Access Compliance Report

Public Rights-of-Way

Intersection ID: 23437	Main Street: MOSS_RD	Cross Street: S_TRYON_ST	Location: NW
ADA ID: 9D9DA74D5700	Ramp Type: Perp	Initial Pass/Fail: Fail	Overall Compliance: No
Severity Score: 21.25			
Codes/Mitigation Info/Possible Solution		Field Measurements/Component Compliance

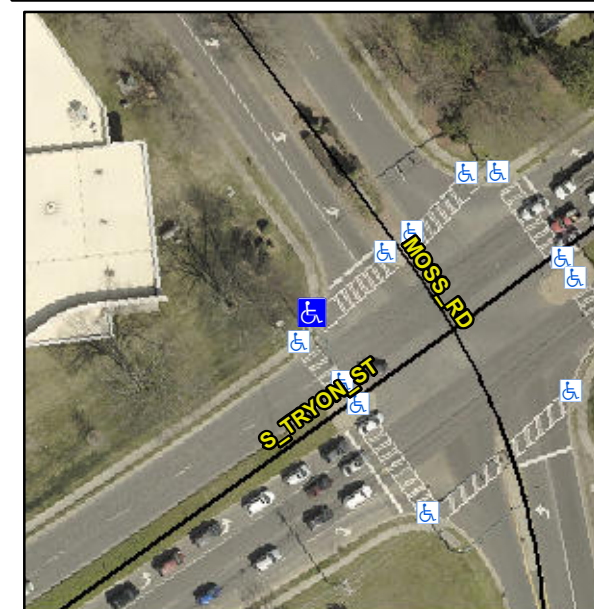
Not Found, R304.5.1, R304.2.2

Compliance	Description	Data	Compliance	Description	Data
N/A	Ramp Length (in)	55.0	No	Ramp Slope (%)	9.0
No	Ramp Width (in)	46.0	Yes	Ramp XSlope (%)	1.6
N/A	Flare Type LT	N/A	N/A	Flare Type RT	N/A
N/A	Flare Slope LT (%)	N/A	N/A	Flare Slope RT (%)	N/A
N/A	Flare Traversable LT?	N/A	N/A	Flare Traversable RT?	N/A
N/A	Landing Length (in)	N/A	N/A	DWS Provided?	N/A
N/A	Landing Width (in)	N/A	N/A	DWS Contrast?	N/A
N/A	Landing Slope (%)	N/A	N/A	DWS Length (in)	N/A
N/A	Landing X Slope (%)	N/A	N/A	DWS Full Width?	N/A
N/A	Landing Curb? (Y/N)	N/A	N/A	DWS Offset (in)	N/A
N/A	Shared Landing?	N/A			
N/A	Gutter Ponding?	N/A	N/A	Gutter Slope (%)	N/A
N/A	Gutter Lip Ht (in)	N/A	N/A	Gutter X Slope (%)	N/A
N/A	Painted X Walk1?	Yes	N/A	Painted X Walk2?	N/A
	X Walk 1 Direction	To NE		X Walk 2 Direction	N/A
N/A	X Walk 1 Width (in)	118.0	N/A	X Walk 2 Width (in)	N/A
	X Walk 1 Slope (%)	1.0		X Walk 2 Slope (%)	N/A
	X Walk 1 X Slope (%)	3.4		X Walk 2 X Slope (%)	N/A

Remove & Replace Entire Ramp.
